# Town of Poughkeepsie

### A.5. 51 VASSAR ROAD

**SEQRA Review, Site Plan Review, and Architectural Review** for the redevelopment of a parcel to include construction of a ±10,640 square foot building for retail use. 51 Vassar Road; Red Oaks Mill Neighborhood Services Center (ROMNSC) Zoning District; ±4.58 acres; Grid #: 6260-04-565213; Unlisted Action; *Calito Development Group, LLC c/o Matt Eucalito (Applicant) and Oak Mill Plaza LLC c/o Vincent Destaso (Owner)*.

**Re: Amended Site Plan for Calito Development Group, LLC**  
**51 Vassar Road, Poughkeepsie, NY 12603**  
**Parcel ID #134689-6260-04-565213**

3 PROPOSED FRONT ELEVATION (Vassar Rd.)  
SCALE: 1/8"-1'-0"

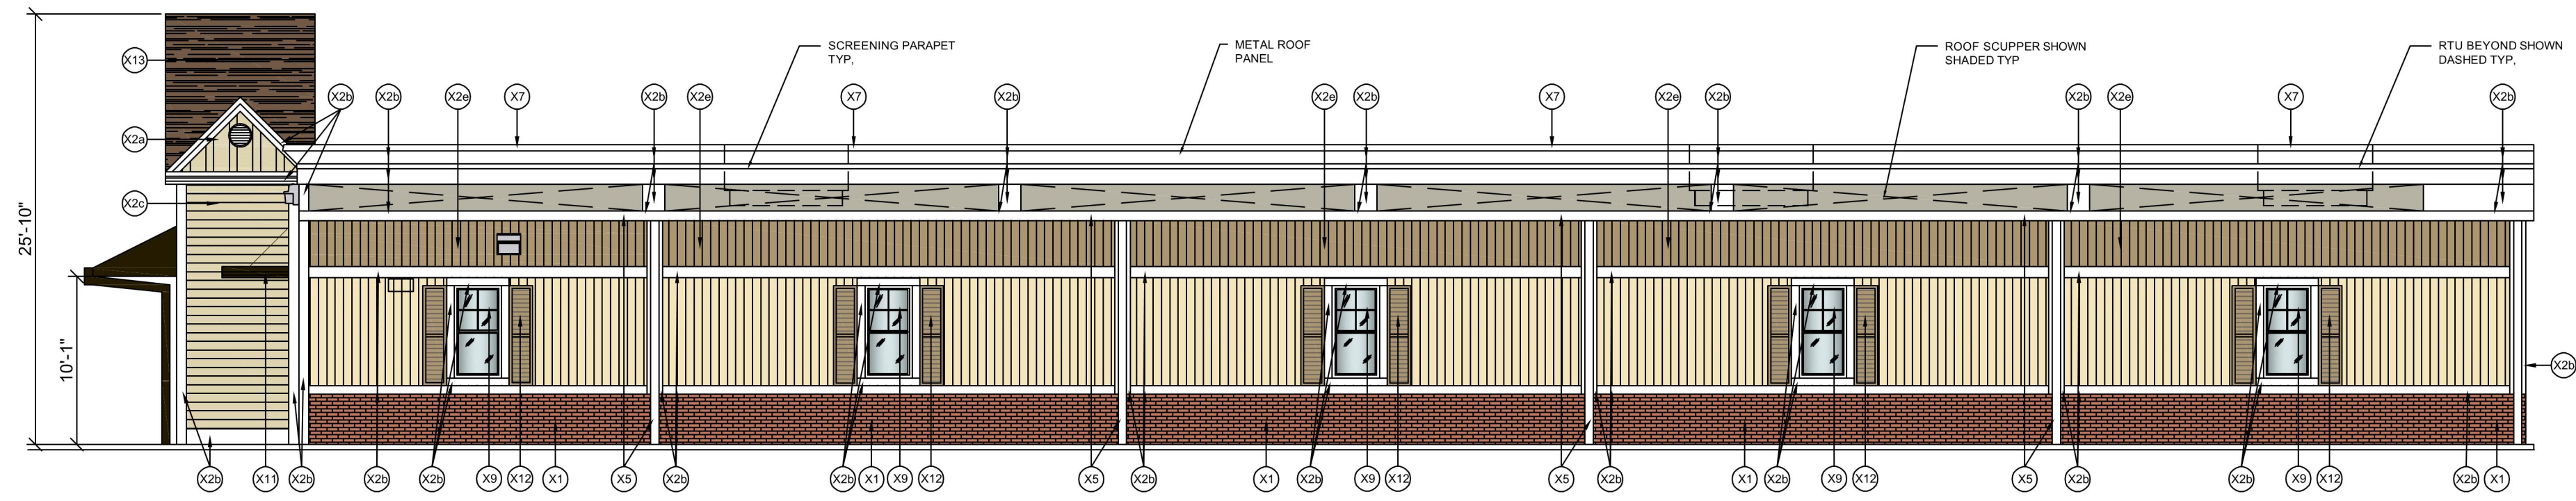
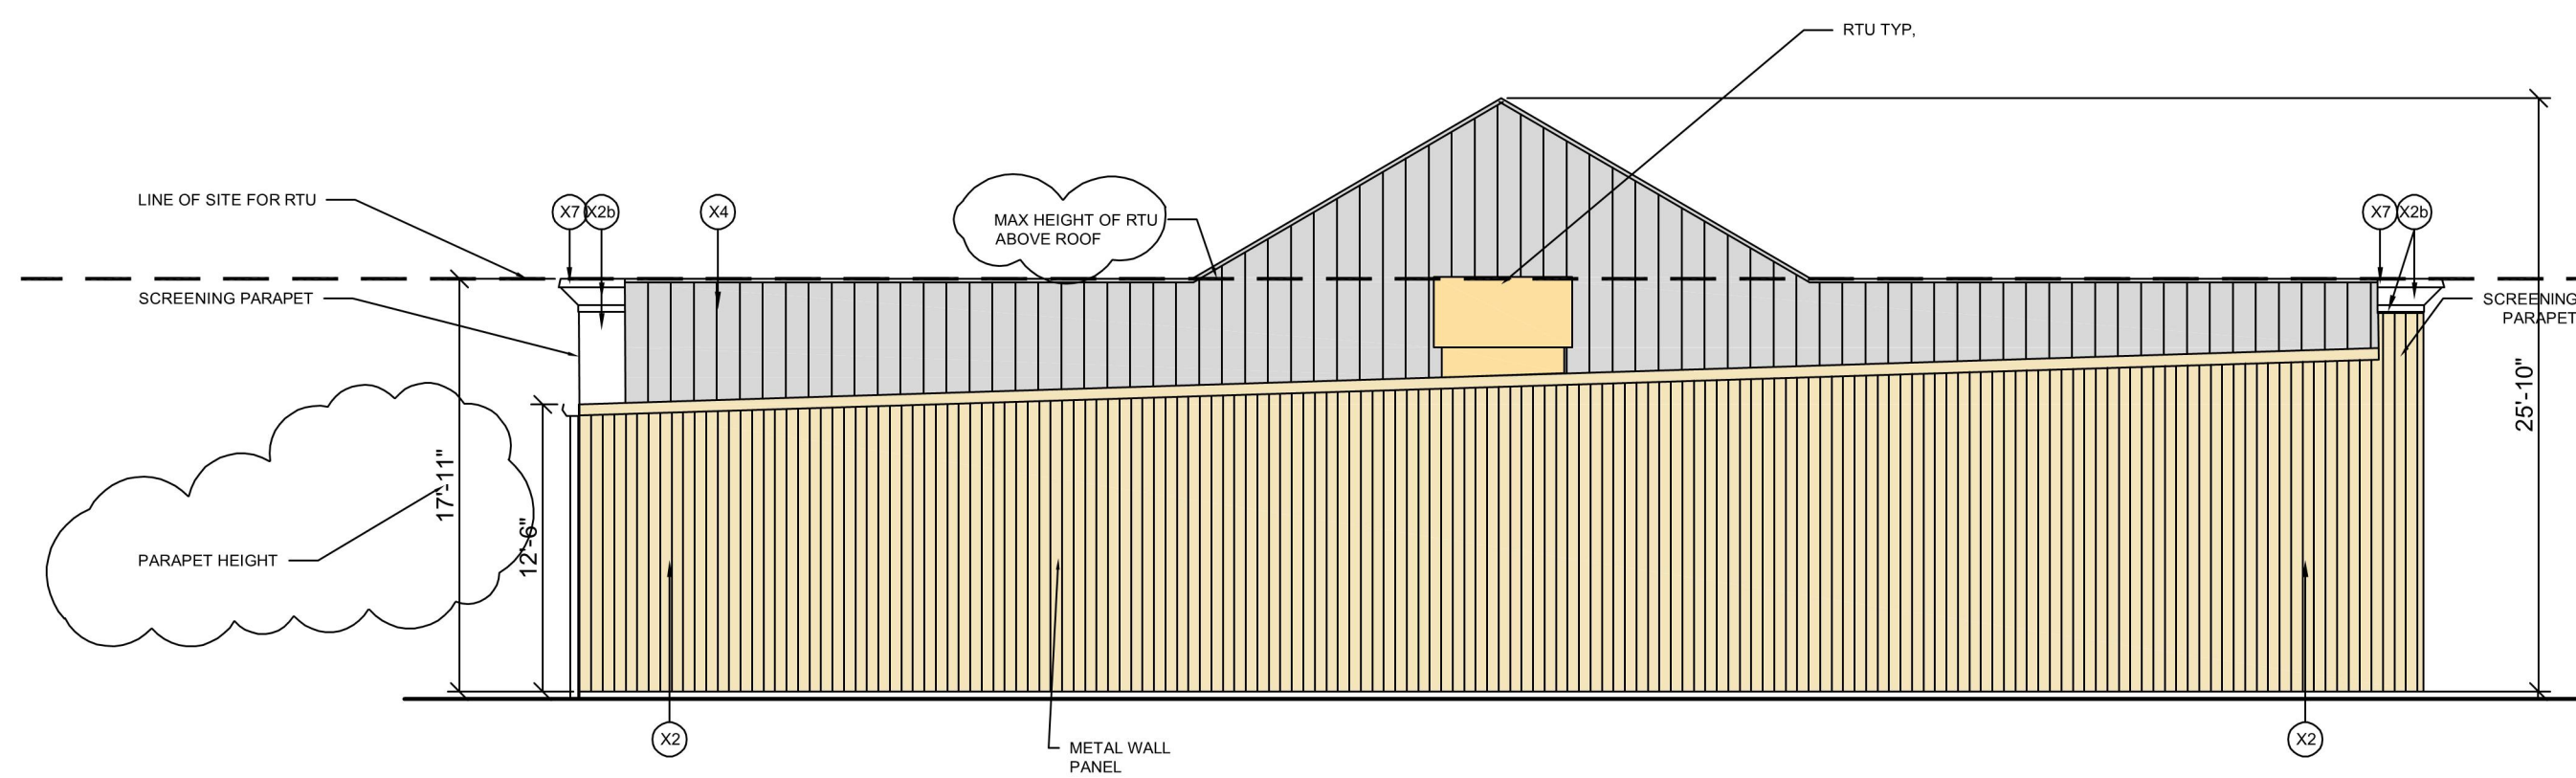
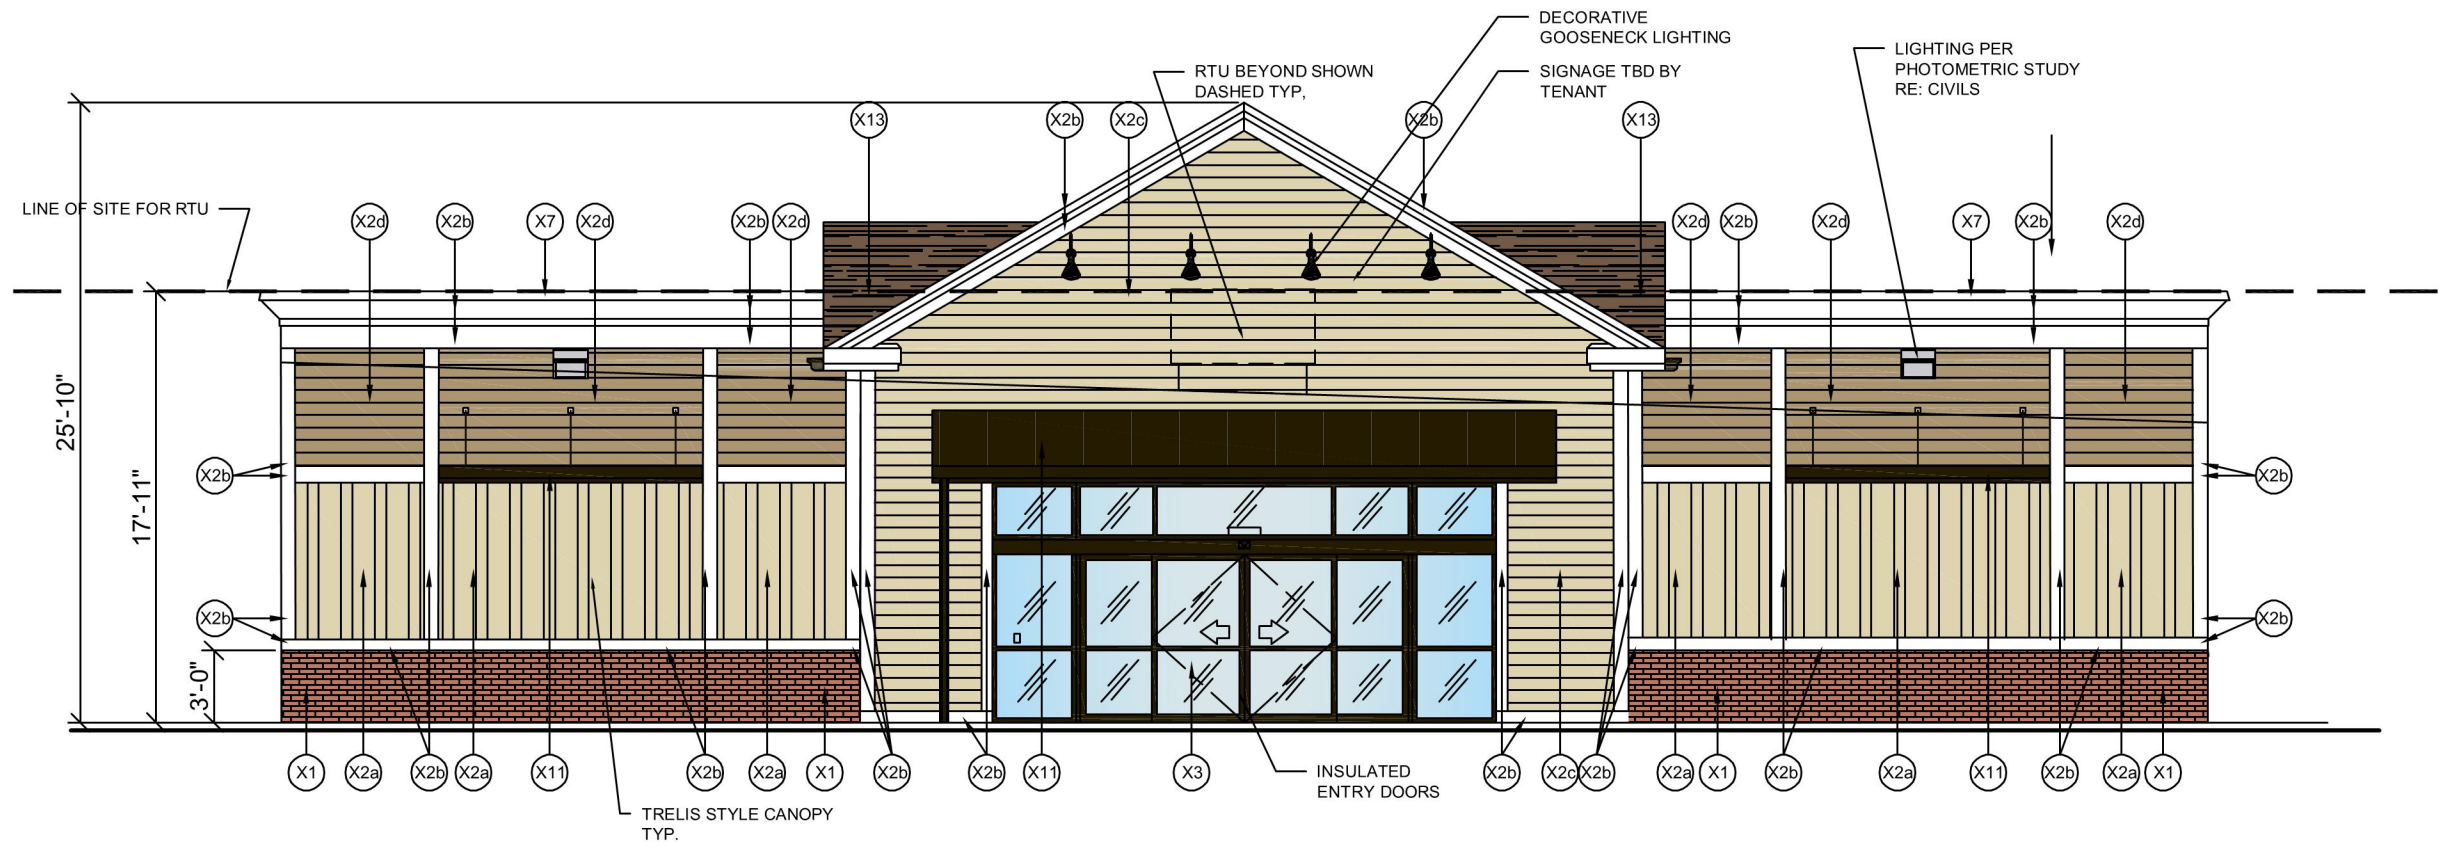
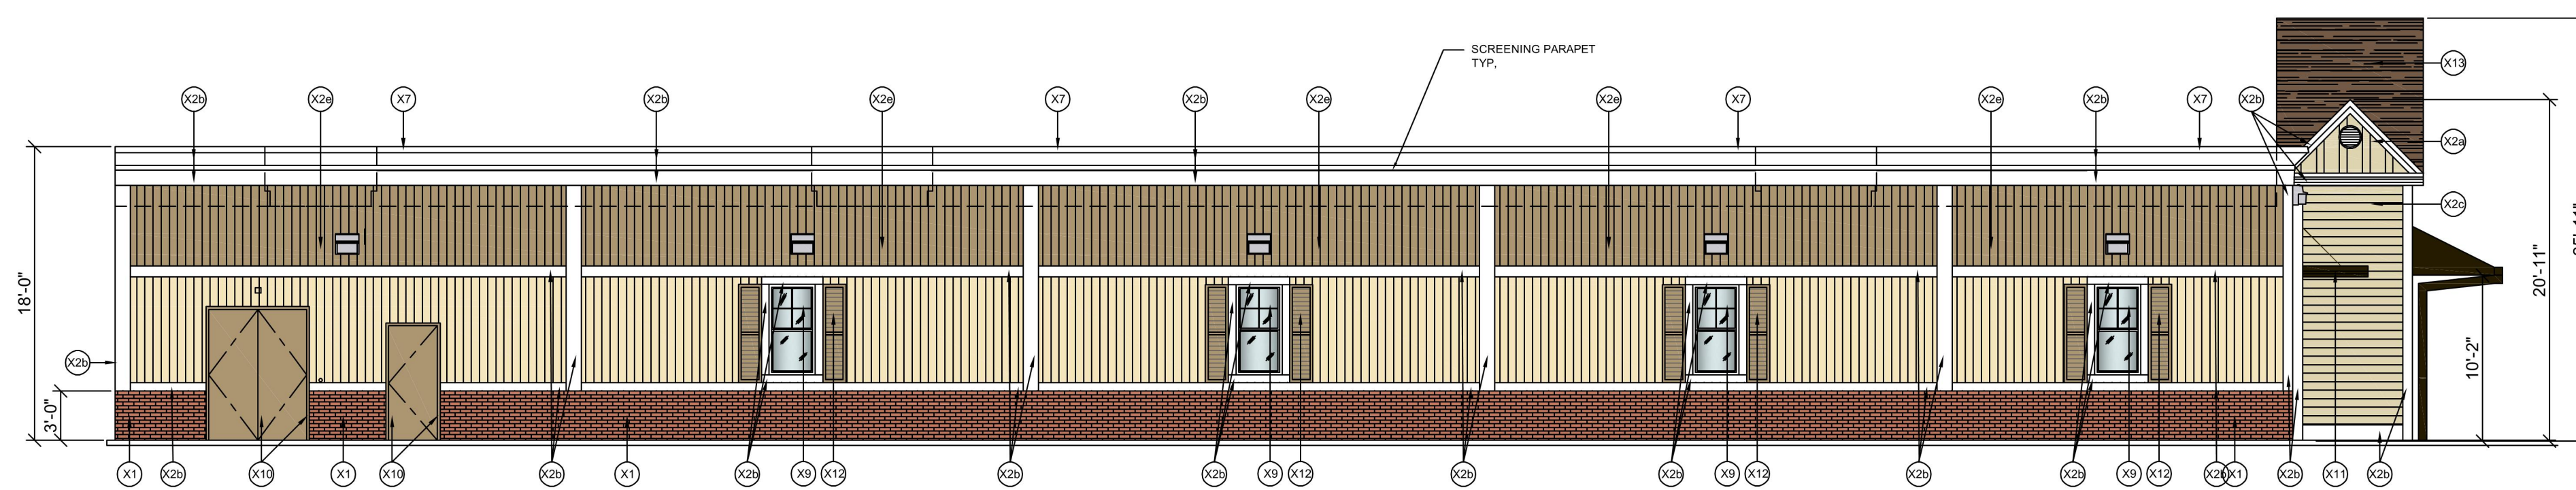
18. Application is subject to architectural review.
- a. Applicant to discuss the proposed east elevation. Planning Board tends to like to see at least a faux window treatment and no blank facades.

**Response: The architect has provided revised elevations showing faux windows as requested.**

**Response: Revised elevations showing the proposed parapet height and RTU typical height have been included with this submission**
